CITY OF BEACON, NEW YORK
THE PLANNING BOARD WILL
MEET ON TUESDAY, MARCH 9,
2021 AT 7:00 PM. A WORK
SESSION WILL TAKE PLACE
AT 7:00 PM FOR A TRAINING
WORKSHOP, DISCUSSION OF
AGENDA ITEMS AND/OR
TOPICS OF INTEREST TO THE
PLANNING BOARD. THE
REGULAR MEETING WILL
BEGIN IMMEDIATELY
THEREAFTER, BUT NOT
LATER THAN 7:30 PM. DUE TO
PUBLIC HEALTH AND SAFETY
CONCERNS RELATED TO
COVID-19, THE PLANNING
BOARD WILL NOT BE MEETING
IN-PERSON. IN ACCORDANCE
WITH THE GOVERNOR'S
EXECUTIVE ORDER 202.1, THE
FEBRUARY 9, 2021 MEETING
WILL BE HELD VIA
VIDEOCONFERENCING, AND A
TRANSCRIPT WILL BE
PROVIDED AT A LATER DATE.
THE PUBLIC CAN WATCH THE
LIVE MEETING ONLINE AT
YOUTUBE AT
[HTTPS://WWW.YOUTUBE.COM/CHANNEL/UCVPPIGGWZDER](https://www.youtube.com/channel/UCVPPIGGWZDER)
SUDXG. COMMENTS CAN BE
CALLED IN DURING THE
MEETING AT (929) 205-6099;
WEBINAR ID: 878 2021 6064;
PASSWORD: 460733.
COMMENTS CAN ALSO BE
PROVIDED VIA EMAIL NO
LATER THAN 5PM ON MARCH

Planning Board Agenda

To: John Gunn, Chair, and the City of Beacon Planning Board
Date: March 4, 2021
Re: **7 Cross Street, Verizon Small Cell Application**

Re: **416-420 Main Street Site Plan and Subdivision**

Sheet 1 of 1 - Site Plan - Green Space Diagram

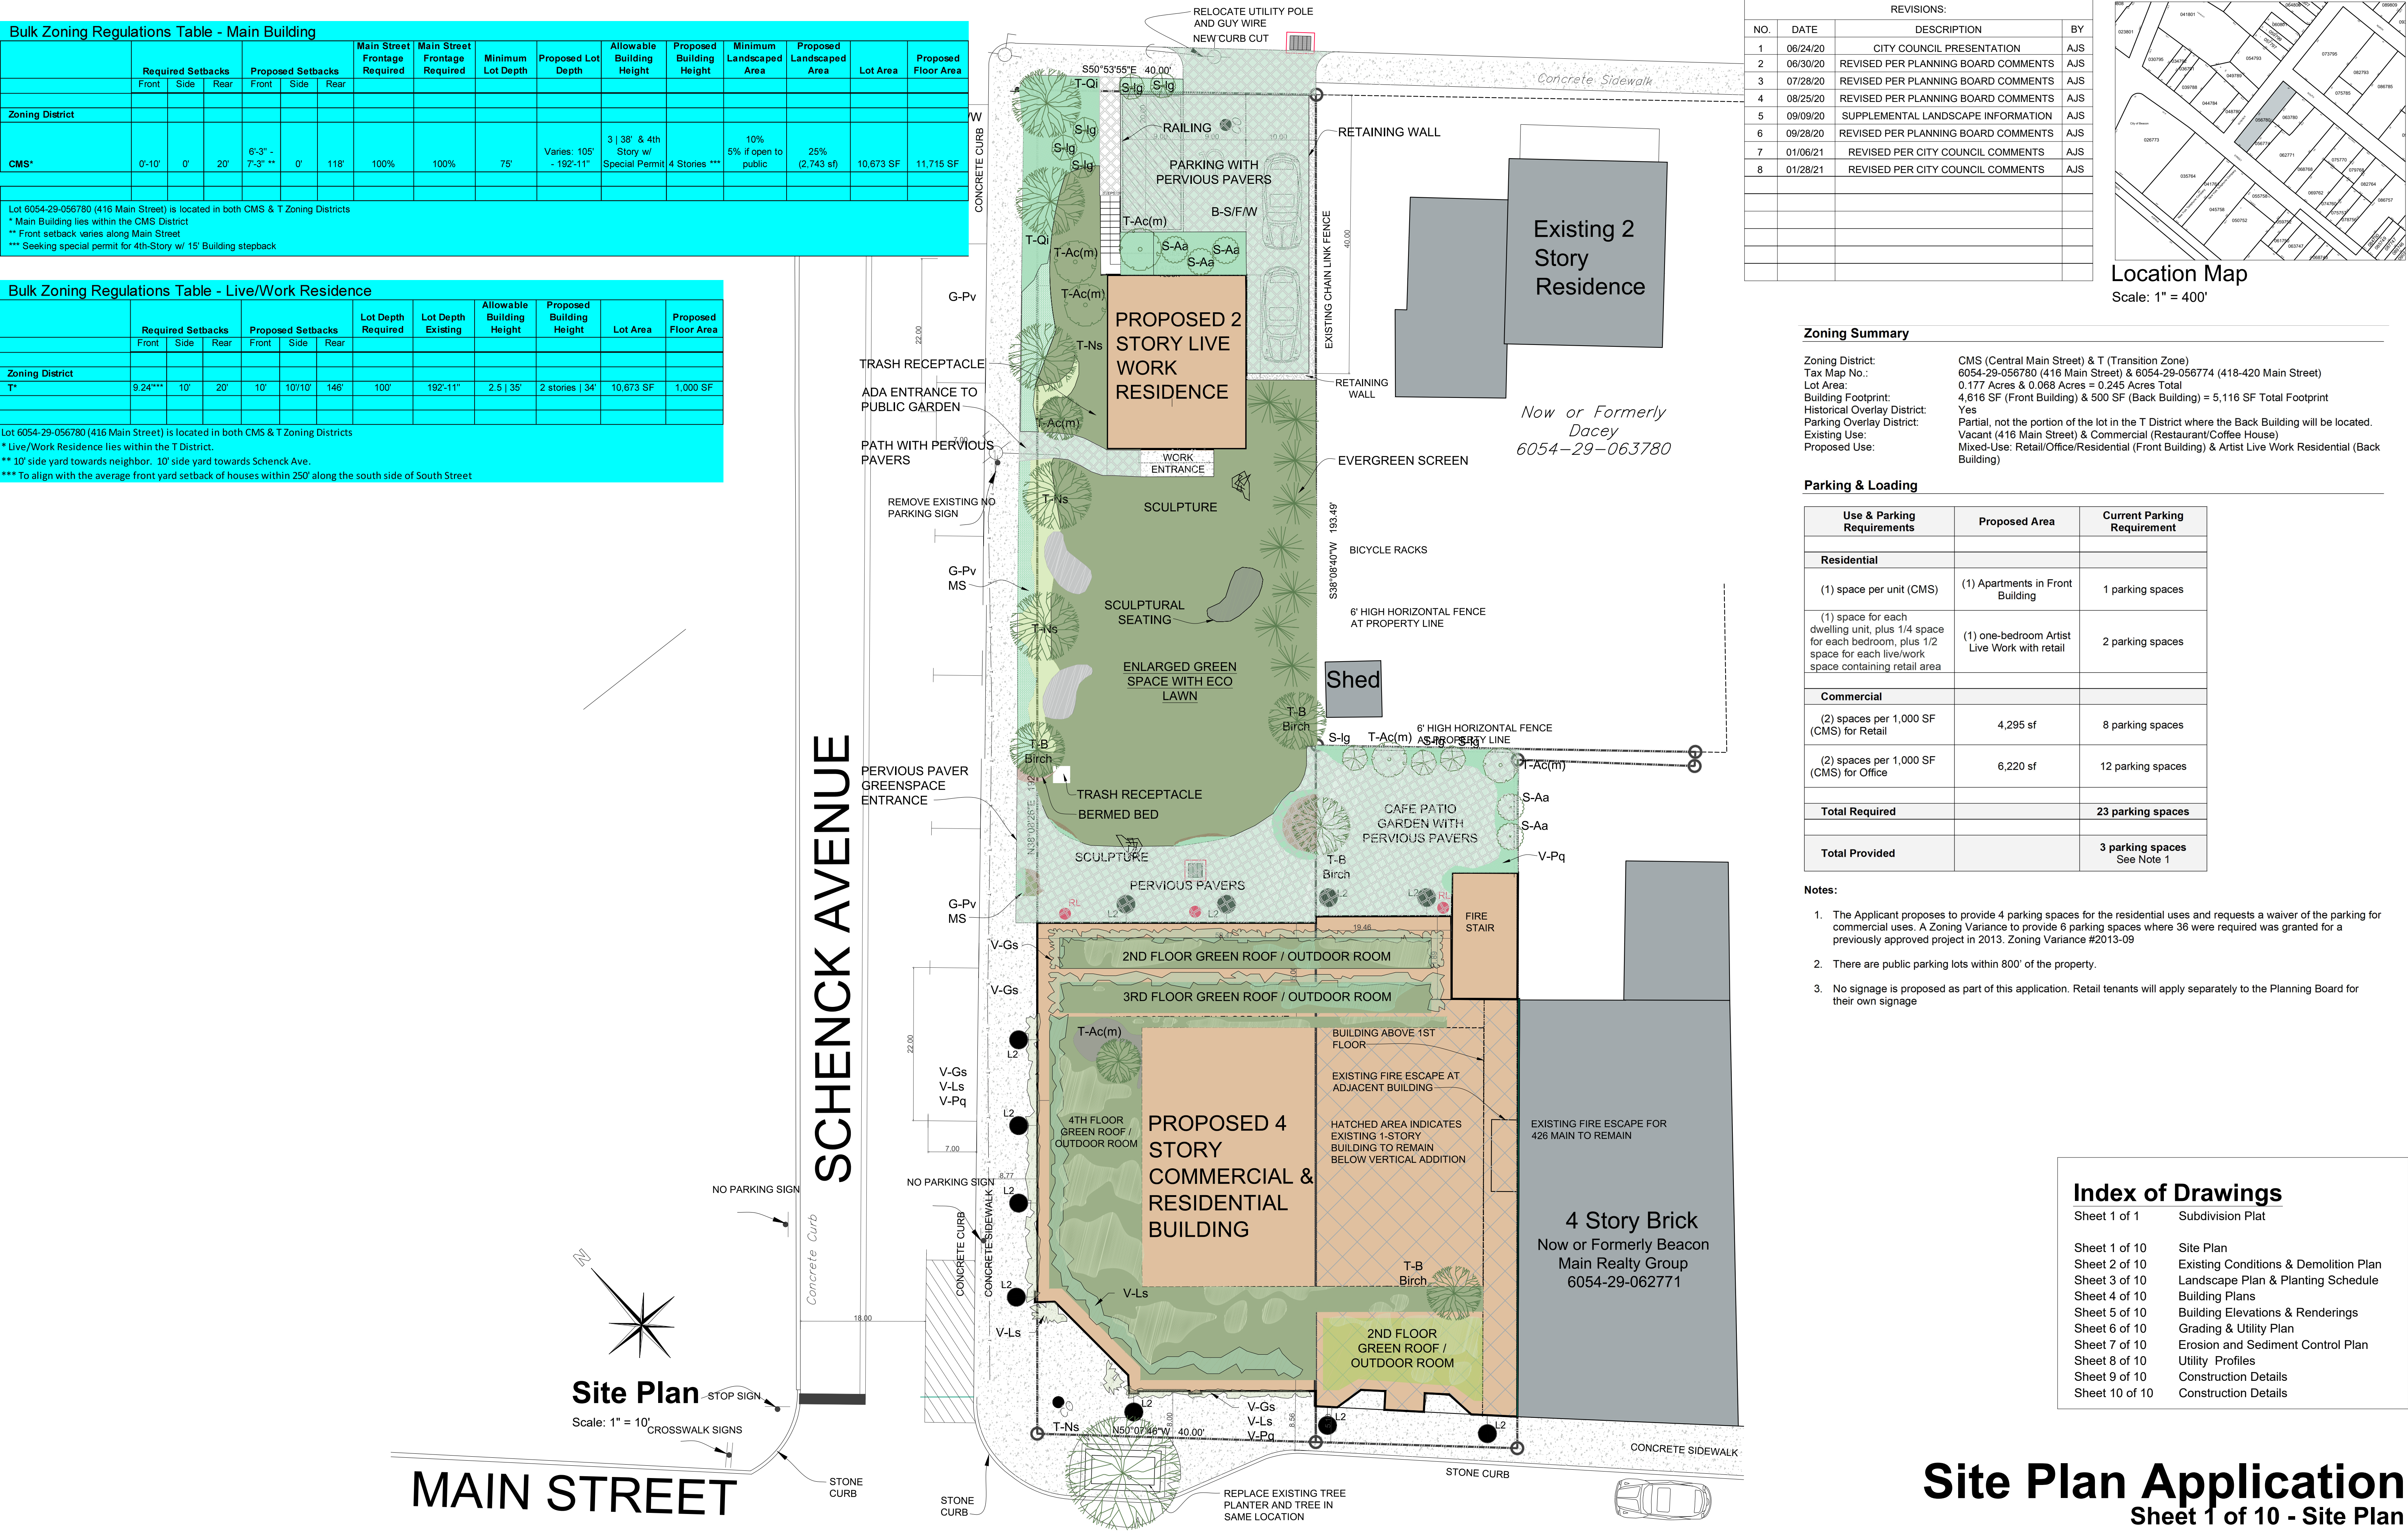
However, the new Site Plan features unattractive front yard parking and conflicts with Section 223-13K, which requires the front yard of any new building to align as nearly as practical to existing buildings within 250 feet on the same side of the street. The five buildings facing South Street directly to the east are set back from the sidewalk from 0 feet to approximate seven feet and even less from the front property lines (porches with roofs count for front setbacks). The proposed live/work setback is 26 feet, which the Building Inspector has indicated does not conform with Section 223-13K. The submitted plan also counts less usable side yards of the live/work building as public greenspace.

1. For the Sheet 1 Site Plan:

- a. The Zoning Table will need to be updated to be consistent with the front setback of the live/work building shown on the plan.

- b. The replacement street tree and planting well should be coordinated with the previous recommendations of the Tree Advisory Committee.
 - c. The fence line and retaining wall along the eastern residential property boundary need to be clarified on the plans. Chain link fencing is not permitted in the HDLO zone.

- d. The methods for trash disposal from the buildings should be described on the plan.
 - e. The sidewalk should be shown as continuing across the South Street driveway.

Sheet 5 of 10 - Building Elevations & Renderings

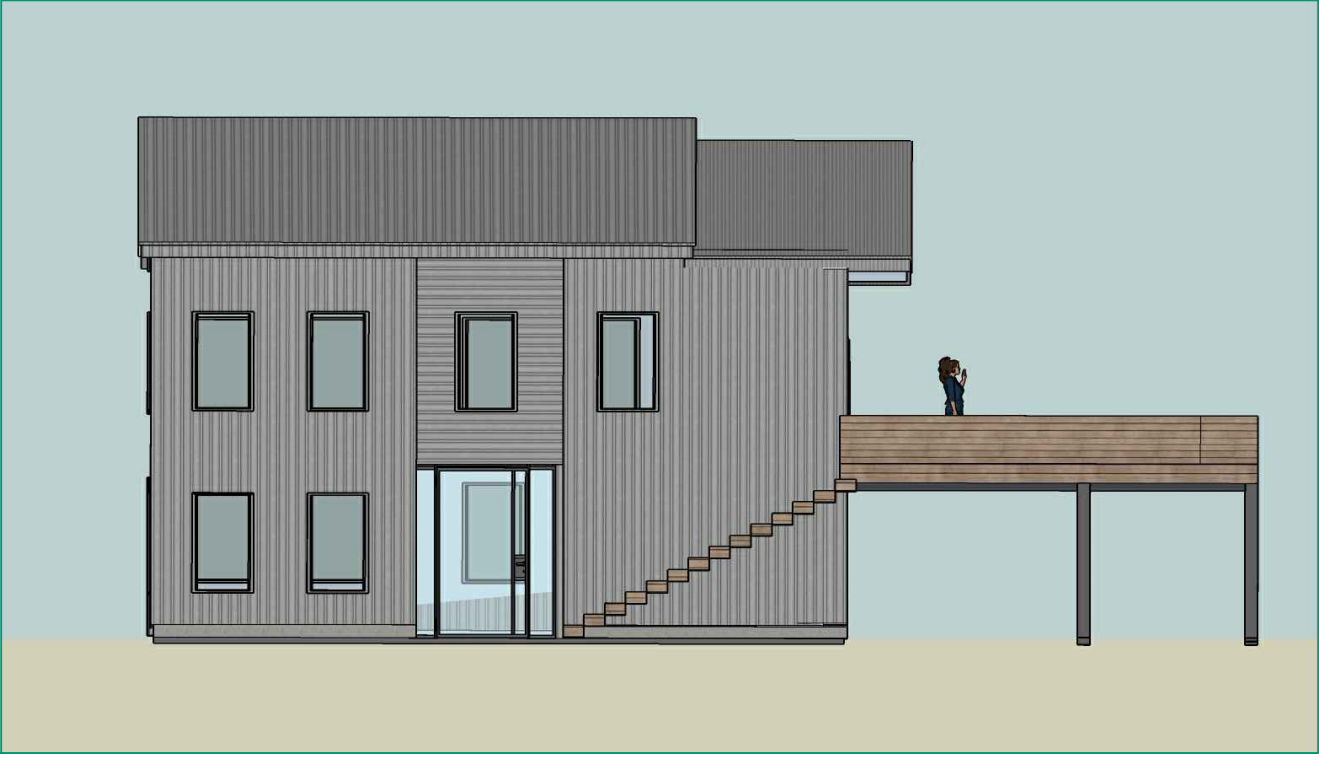
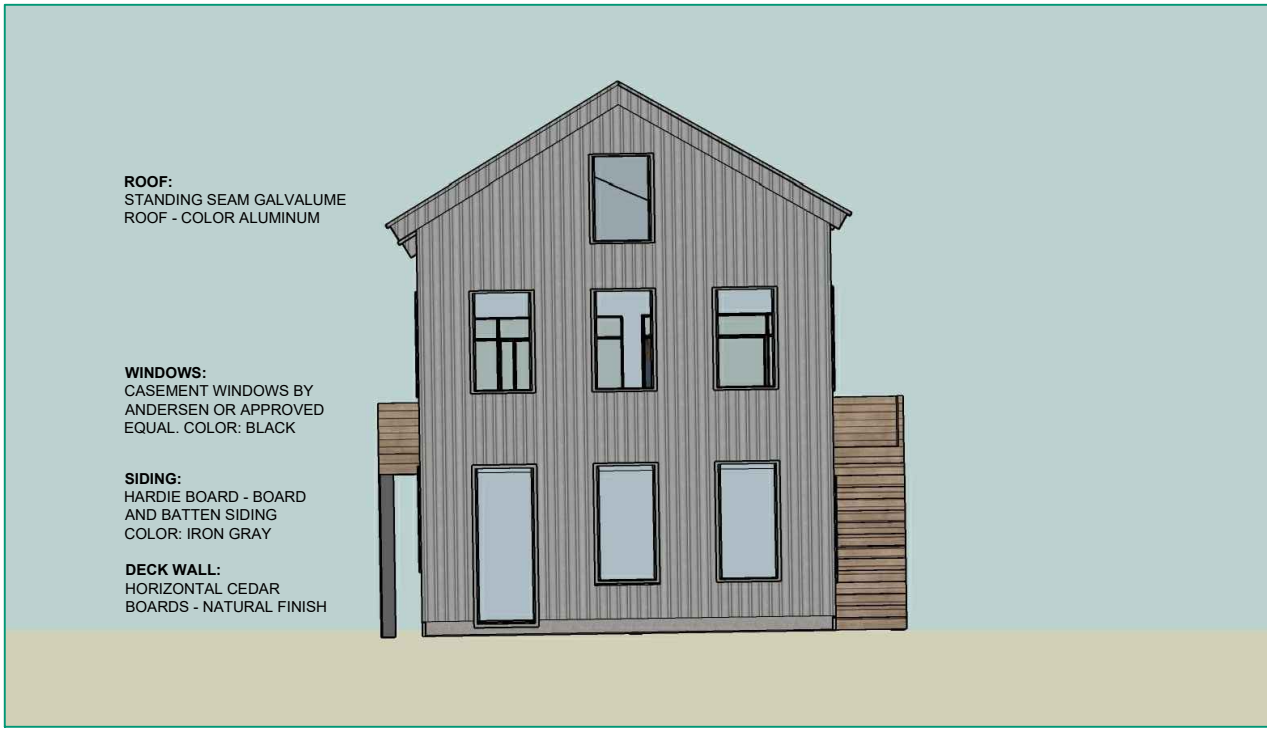
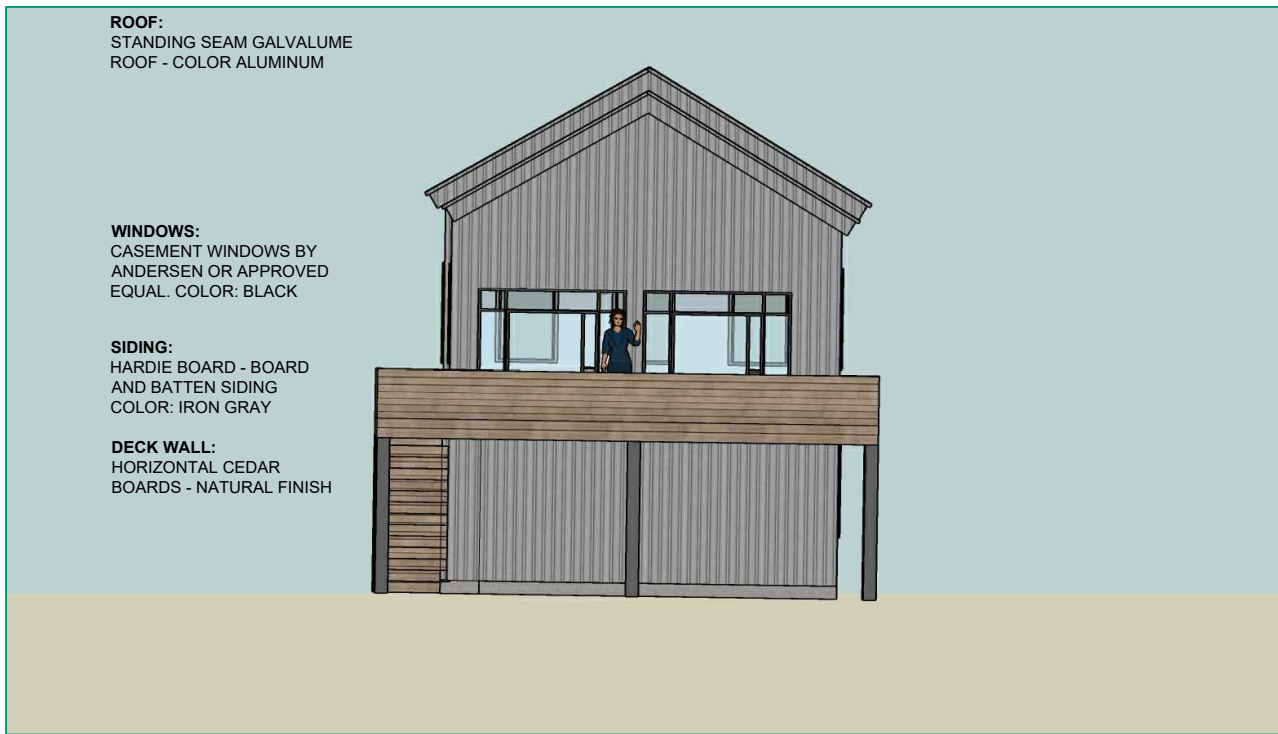
3. For the Sheet 5 Building Elevations and Renderings:
- a. The live/work building elevations may need to be updated to match the Site Plan and major measurements should be added.

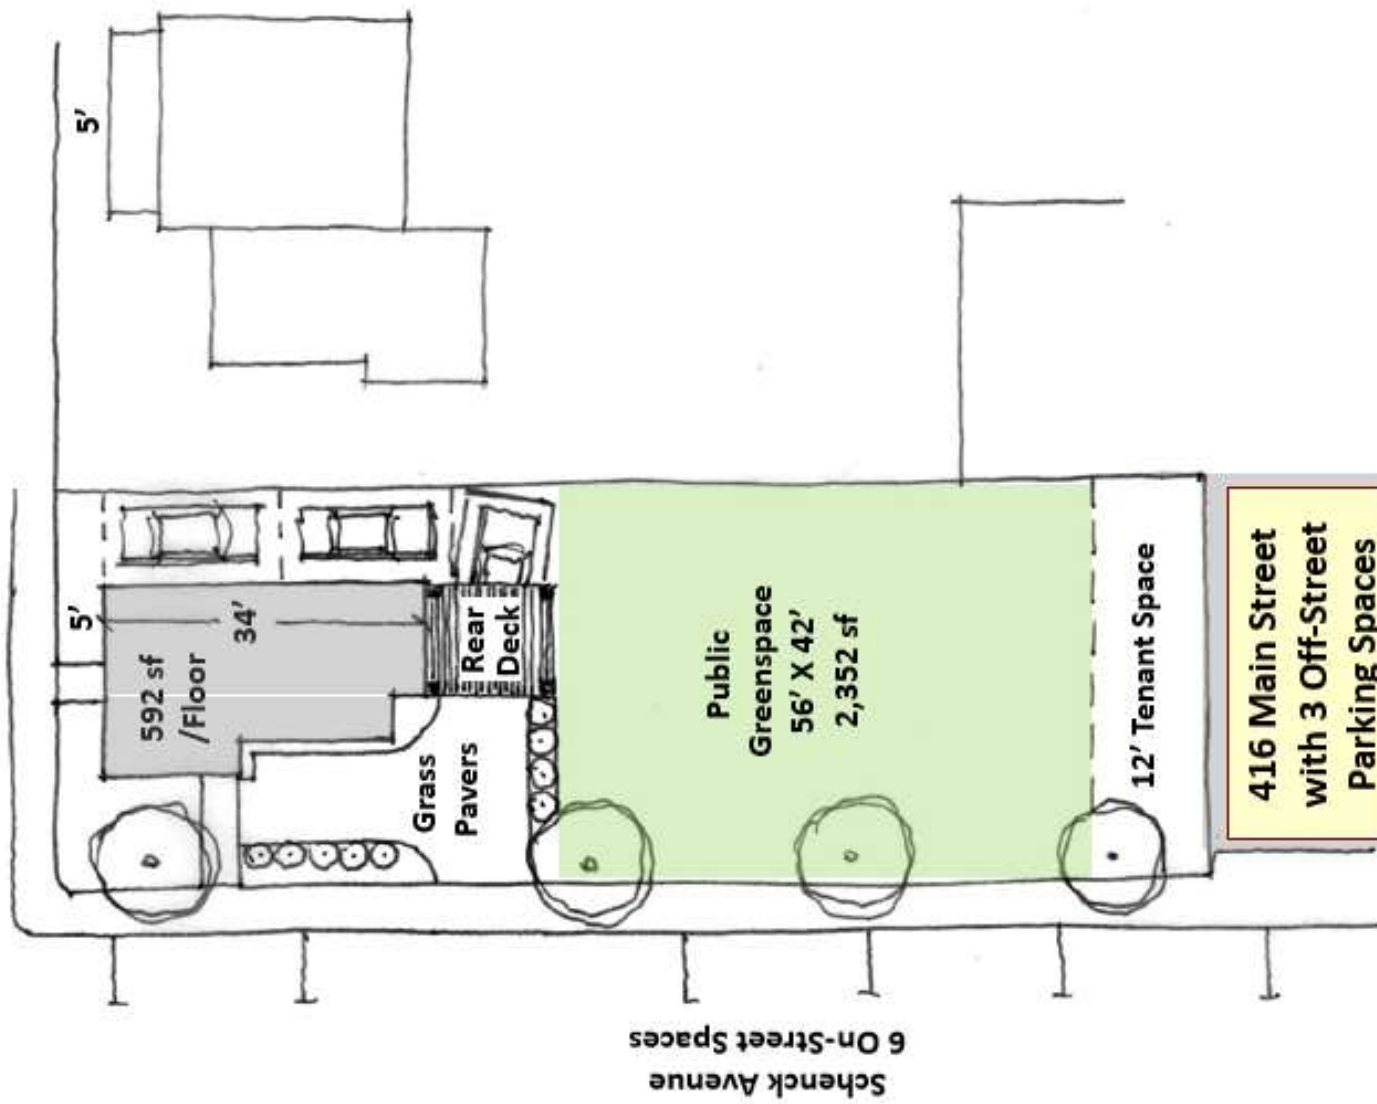
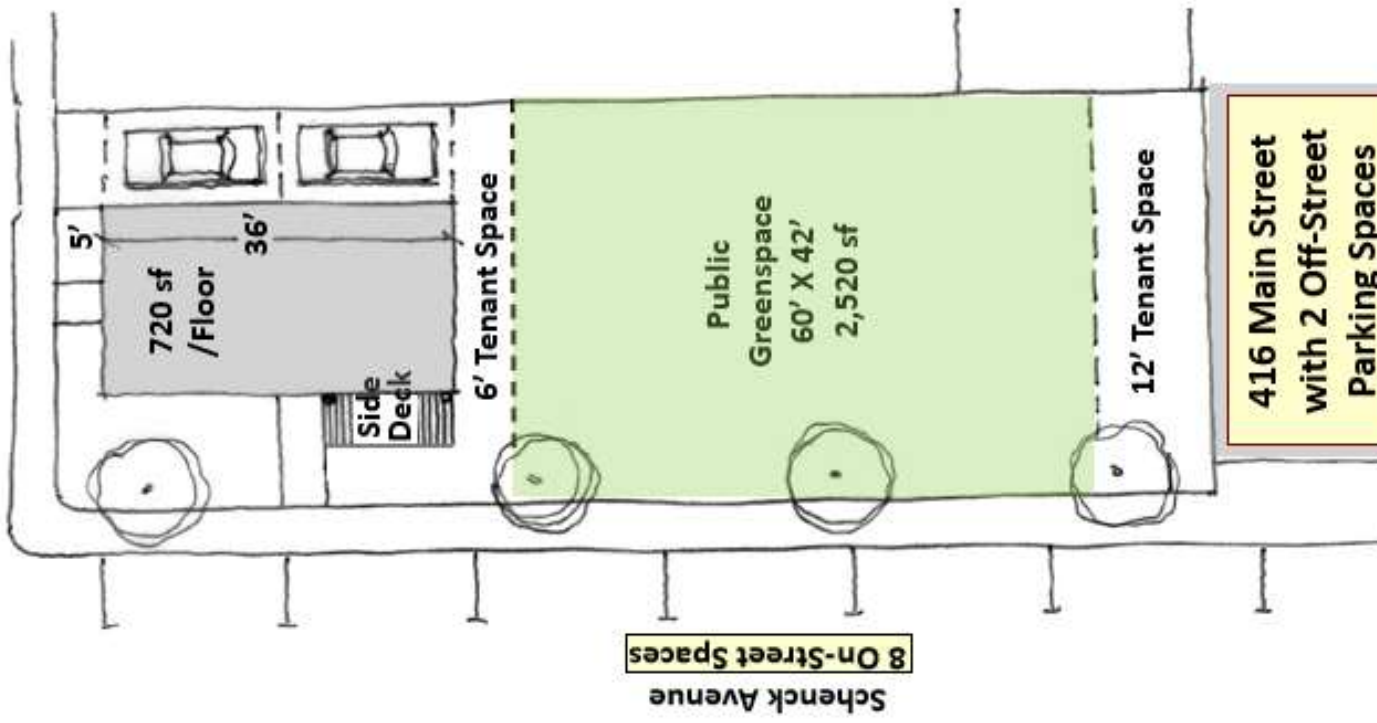
I have attached two concept sketches with two or three off-street parking spaces to illustrate other possible options for a larger, well-defined central public greenspace, as well as more square footage for the live/work building. Other remaining Site Plan issues include the following:
